Subject: Final Work Plan for Injection Well Installation on Parcel Number 650-151-06
Interim Measures No. 3, Pacific Gas and Electric Company, Topock Project

**Work Plan for Injection Well
Installation on Parcel 650-151-06
PG&E Topock Compressor Station
Needles, California**

FIGURE 2-1
SCHEMATIC DIAGRAM OF IM-3 INJECTION WELL
PG&E PARCEL 650-151-06

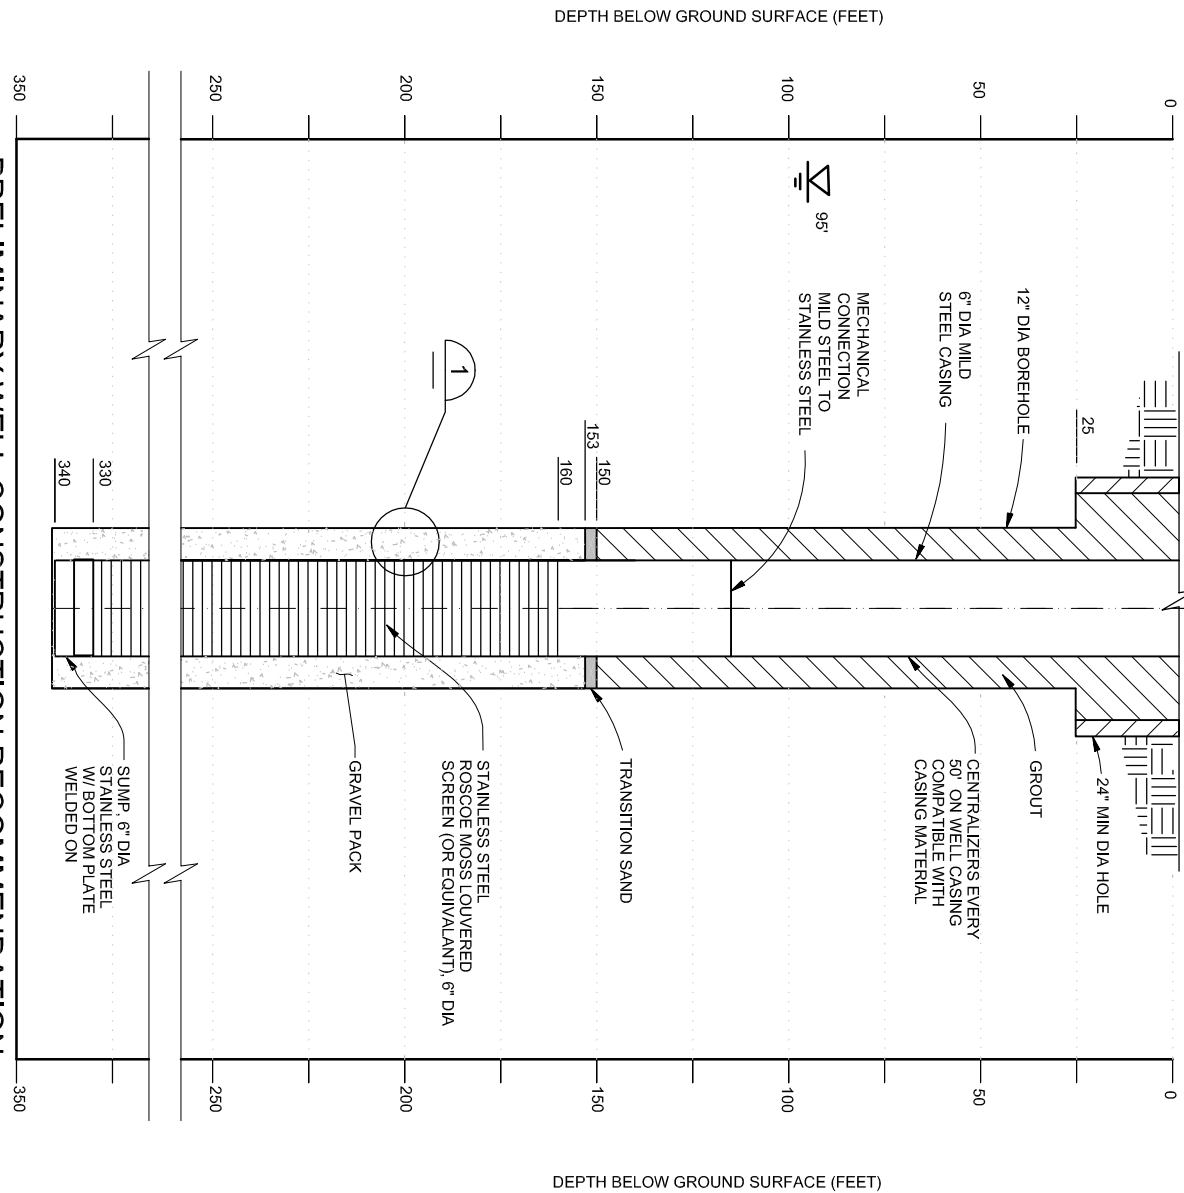
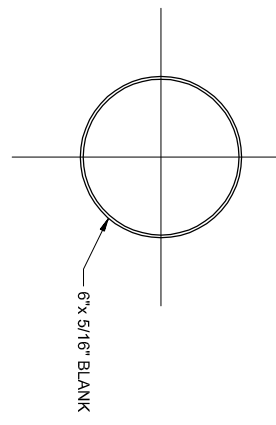
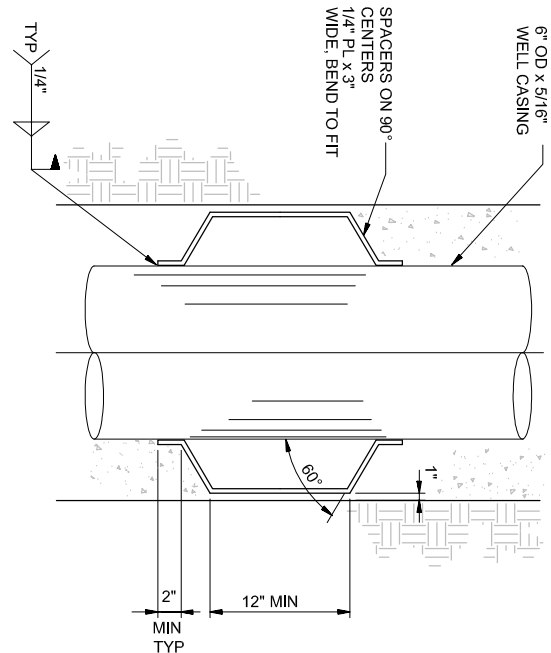
The design of the injection wells has been revised because the results of recent drilling in the vicinity of the proposed injection wells suggest that the aquifer is deeper than originally estimated in this area. Accordingly the screen interval of the injection wells has been revised to 160 to 340 feet below ground surface, approximately 30 feet deeper than the original design. Screening the wells at this lower interval will minimize the chance of cross-

A drawing of a typical injection well and associated details is presented on Figure 2-1. Assuming a water table at 95 feet bgs and a final well depth of 340 feet bgs, the basic injection well design consists of:

- Six-inch-diameter mild steel blank casing from 2 feet above ground surface to 145 feet bgs. The well casing will be fabricated in lengths not less than 20 feet.
- Mechanical coupler to connect mild steel to stainless-steel at approximately 145 feet bgs.
- Six-inch diameter type 304 stainless-steel blank casing from 145 to 160 feet bgs.
- Six-inch-diameter type 304 stainless-steel, louvered screen from 160 feet to 330 feet bgs, 0.06-inch slot (size is currently assumed for bidding purposes only). The well casing will be fabricated in lengths of 20 feet and not less than 10 feet.
- Six-inch-diameter type 304 stainless-steel blank casing (well sump) from 330 to 340 feet bgs.
- A 6-inch-diameter type 304 stainless-steel bull nose to be located at a well depth of about 340 feet bgs.

- Drop tube injection piping.
- Centralizers spaced every 50 feet beginning at 100 feet bgs.
- Gravel pack (Silica Resources or equivalent) from 340 to 153 feet bgs (7 feet above the screened interval after surge-settling).
- Transition sand interval from 153 to 150 feet bgs, consisting of Monterey #30 sand.
- Cement grout seal from 150 to 0 feet bgs.
